RAM9 QDR-I/DDR-I/QDR-II/DDR- II Errata

This document describes the $\overline{\text{DOFF}}$ issue for QDRII/DDR II and the Output Buffer and JTAG issues for QDR I/DDRI/QDR II/DDR II. Details include trigger conditions, possible workarounds and silicon revision applicability. This document should be used to compare to the respective datasheet for the devices to fully describe the device functionality.

Figure 1 shows the DOFF pin circuit with an internal 5K Ω internal resistor. The fix planned is to disable the internal 5K Ω leaker.

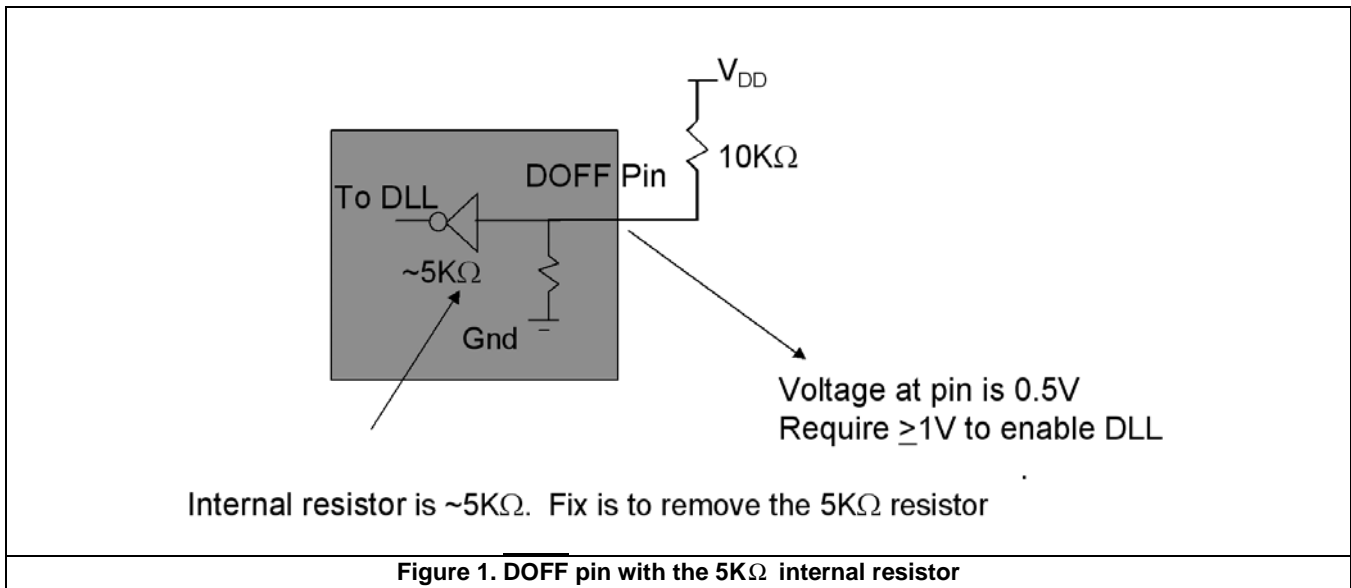
This issue involves the DLL not turning ON properly if a large resistor is used (eg:-10K Ω) as an external pullup resistor to enable the DLL. If a 10K Ω or higher pullup resistor is used externally, the voltage on DOFF is not high enough to enable the DLL.

Fix involved removing the internal pull-down resistor on the $\overline{\text{DOFF}}$ pin. The fix has been implemented on the new revision and is now available. The new revision is an increment of the existing revision. The following table lists the devices affected, current revision and the new revision after the fix.

Figure 2 shows the proposed workaround and the fix planned.

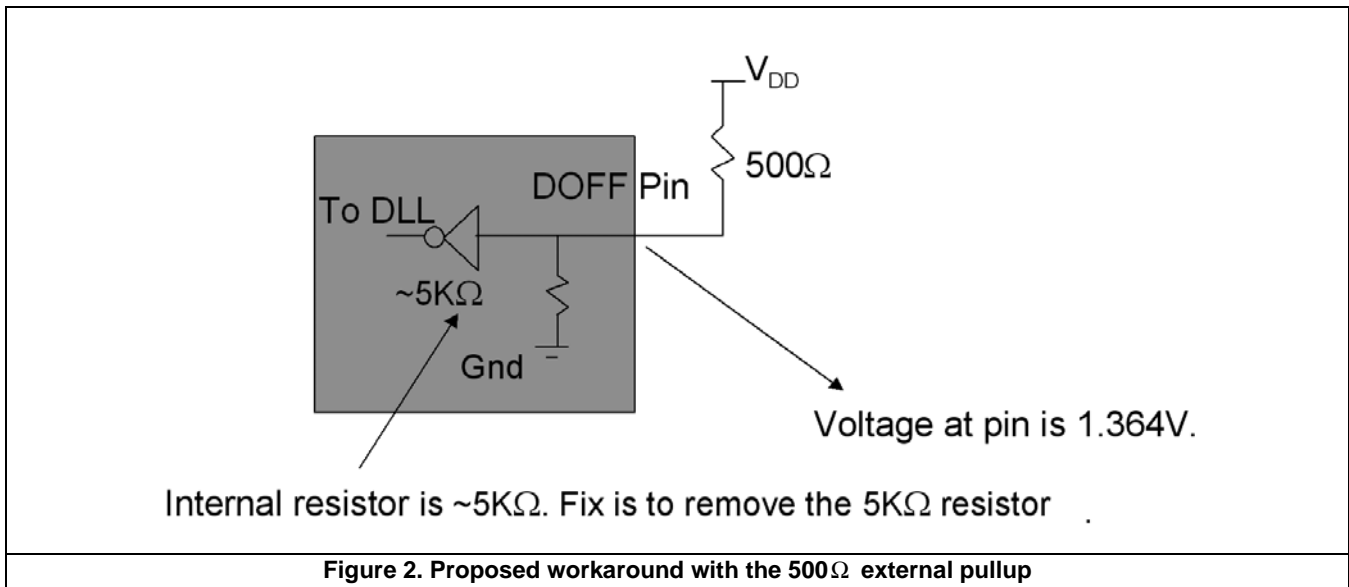
The workaround is to have a low value of external pullup resistor for the $\overline{\text{DOFF}}$ pin (recommended value is $\leq 500\Omega$). When $\overline{\text{DOFF}}$ pins from multiple QDR devices are connected through the same pull-up resistors on the board, it is recommended that this $\overline{\text{DOFF}}$ pin be directly connected to V_{DD} due to the lower effective resistance since the "leakers" are in parallel.

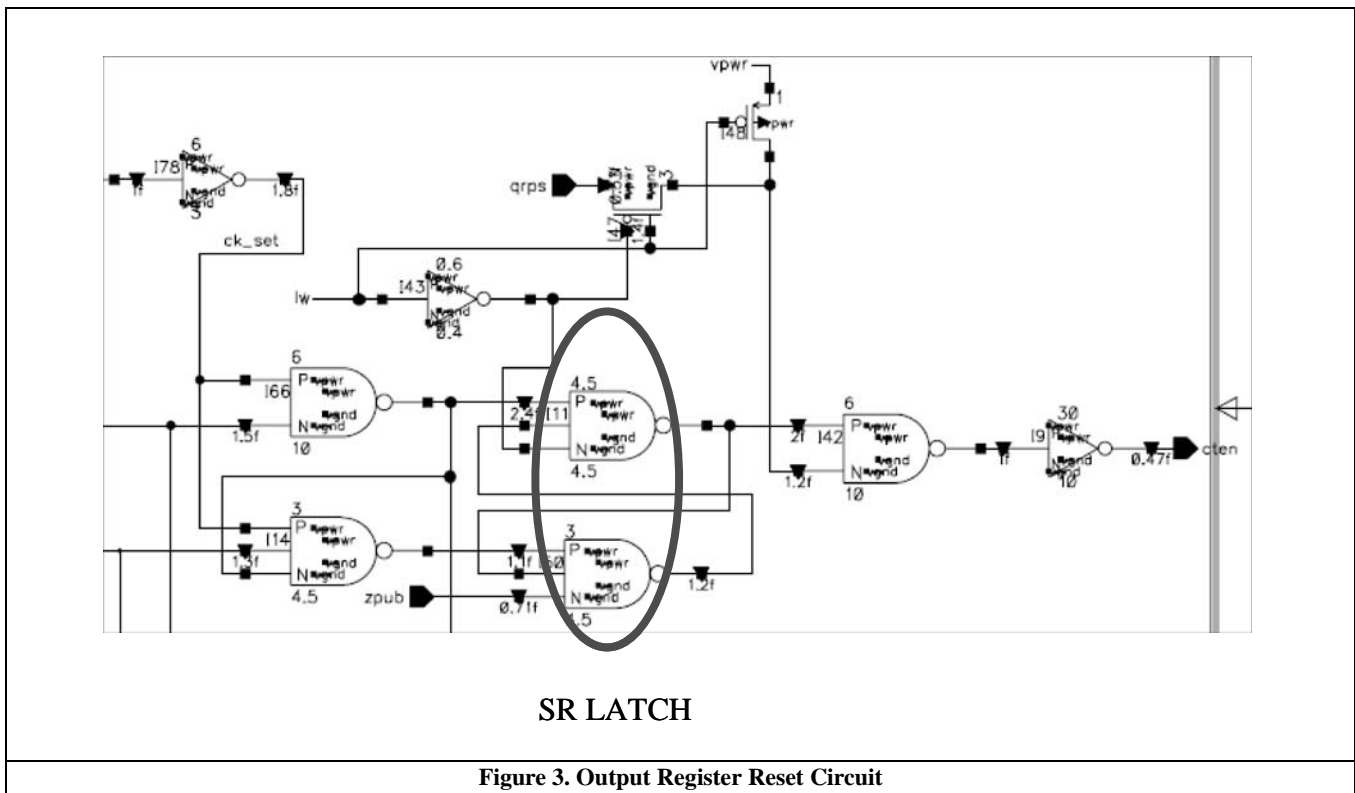
This issue involves the output buffer entering an unidentified state when the input signals (only Control signals or Clocks) are floating during reset or initialization of the memory controller after power up.

Figure 3 shows the output register Reset circuit with an SR Latch circled. This latch has two inputs with one of them coming from some logic affected by the clock and RPS#(QDR) or WE# and LD#(DDR). The issue happens when clocks are glitching/toggling with controls floating. This will cause the SR latch to be taken into an unidentified state. The SR Latch will need to be reset by a dummy read operation if this happens.

The fix has been implemented on the new revision and is now available. The new revision is an increment of the existing revision. Please refer to Table 4 for the list of devices affected, current revision and the new revision after the fix.

Figure 4. Dummy Read Implementation

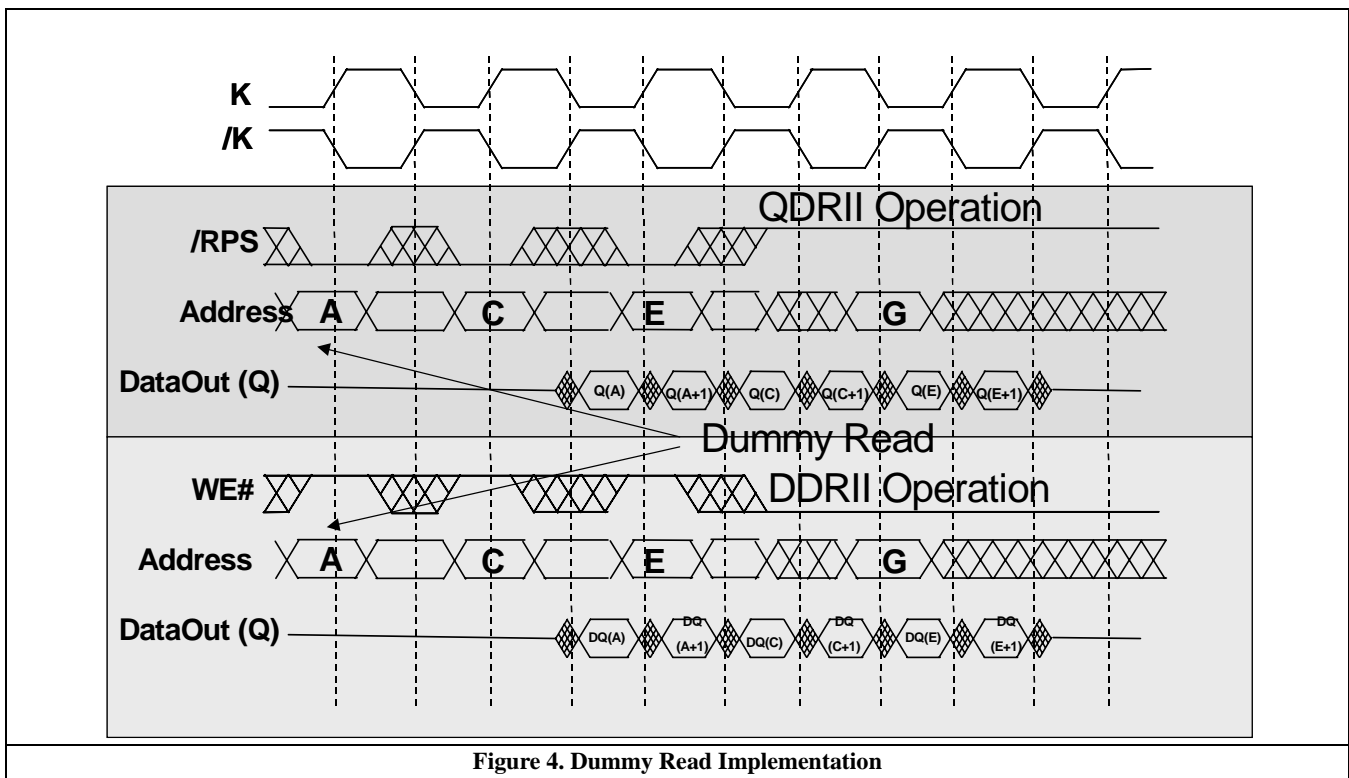
This is viable only if the customer has the trigger conditions met during reset or initialization of the memory controller after power up. In order for the workaround to perform properly, Cypress recommends the insertion of a minimum of 16 “dummy” READ operations to every SRAM device on the board prior to writing any meaningful data into the SRAM. After this one “dummy” READ operation, the device will perform properly. “Dummy” READ is defined as a read operation to the device that is not meant to retrieve required data. The “dummy” READ can be to any address location in the SRAM. Refer to Figure 4 for the dummy read implementation.

In systems where multiple SRAMs with multiple RPS# lines are used, a dummy read operation will have to be performed on every SRAM on the board. Below is an example sequence of events that can be performed before valid access can be performed on the SRAM.

- 1) Initialize the Memory Controller
- 2) Assert RPS# Low for each of the memory devices

- 1) For the 72M / 36M / 18M x9 devices drive address pin A2 / A10 / A3 low respectively and perform dummy read.
- 2) For the 72M / 36M / 18M x9 devices drive address pin A2 / A10 / A3 high respectively and perform dummy read.
